CITY OF ALBUQUERQUE

Re: Winnelson Wake House Remodel Addition 3545 Princeton Dr NE Traffic Circulation Layout Architect's Stamp 09-26-16 (G16D152)

Based upon the information provided in your submittal received 10-13-16, the above referenced plan cannot be approved for Building Permit until the following comments are addressed:

SITE PLAN SCALE: 1/20" = 1'-0"

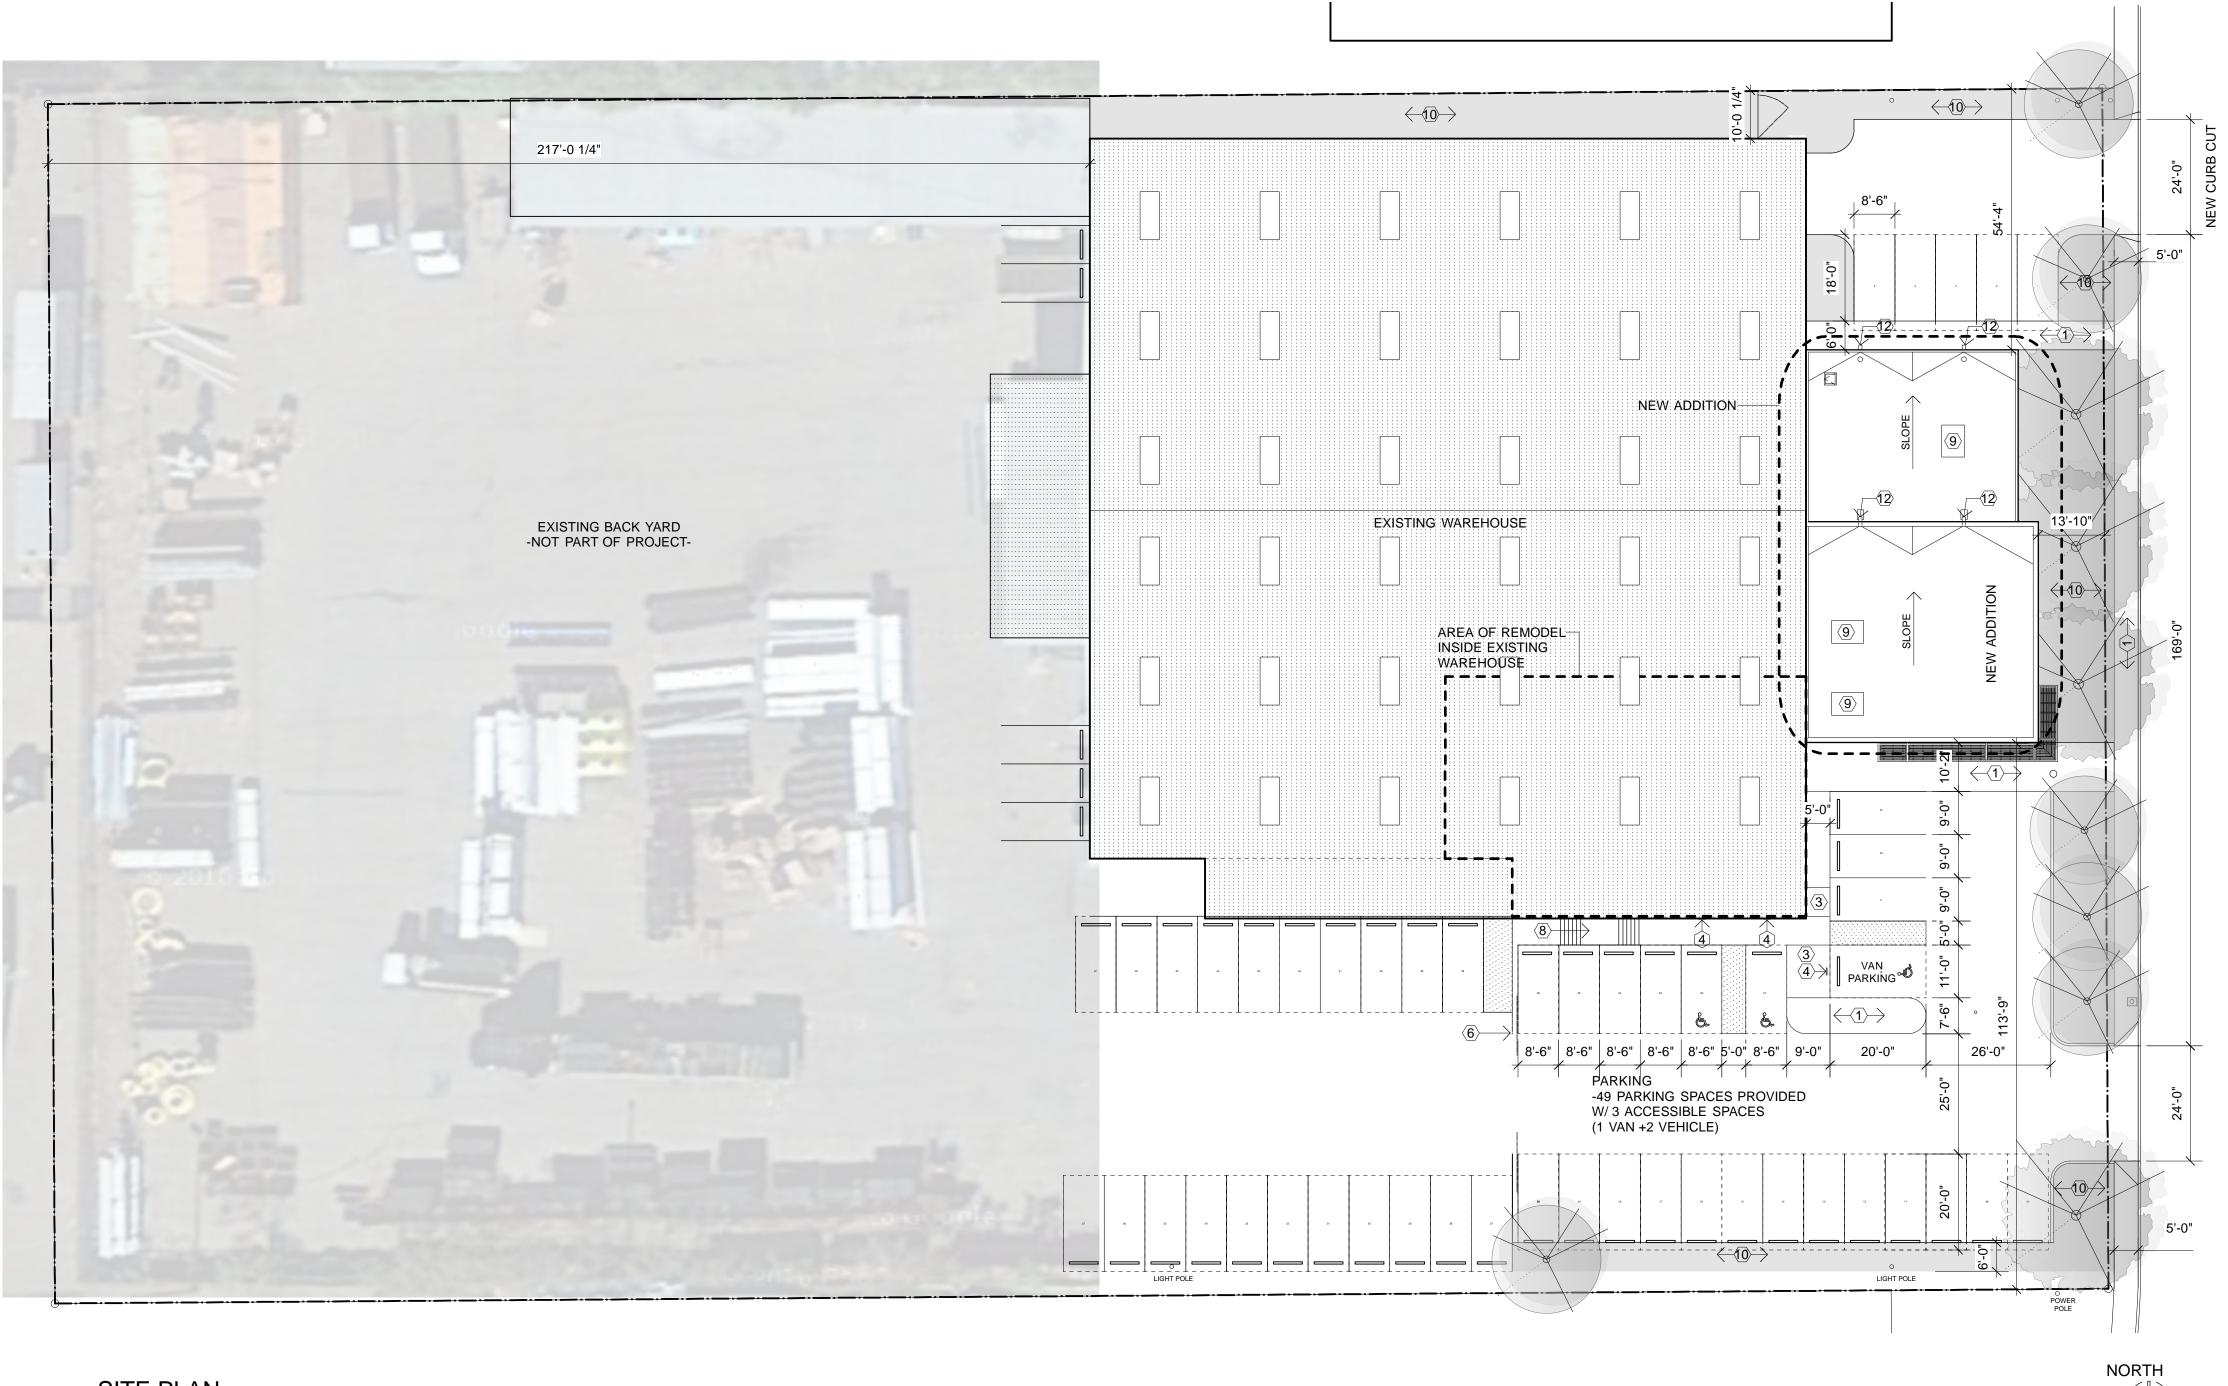
- 1. Identify the right of way width and label on Princeton Dr NE.
- 2. Please list the width and length for all existing and proposed parking spaces. Some dimensions are not shown.

- The ADA access aisles shall have the words "NO PARKING" in capital letters, each of which shall be at least one foot high and at least two inches wide, placed at the rear of the parking space so as to be close to where an adjacent vehicle's rear tire would be placed. (66-1-4.1.B NMSA 1978)

- 4. A 5 ft. keyway is required for dead-end parking aisles.
- Per DPM. a 6 ft. wide ADA accessible pedestrian pathwa
- Per DPM, a 6 ft. wide ADA accessible pedestrian pathway is required from the HC parking stall access aisles to the building entrances. Please clearly show this pathway and provide details.

- 6. Call out where motorcle parking and bicycle parking is located on site plan.
- All sidewalks along streets should be placed at the property line.
- 8. Show the clear sight triangle and add the following note to the plan: "Landscaping and signage will not interfere with clear sight requirements. Therefore, signs, walls, trees, and shrubbery between 3 and 8 feet tall (as measured from the gutter pan) will not be acceptable in the clear sight triangle.

- 9. Unused curb cuts must be replaced with sidewalk and curb & gutter. A build note must be provided referring to the appropriate City Standard drawing.

- 10. Please specify the City Standard Drawing Number when applicable.
- 11. Please include two copies of the traffic circulation layout at the next submittal.
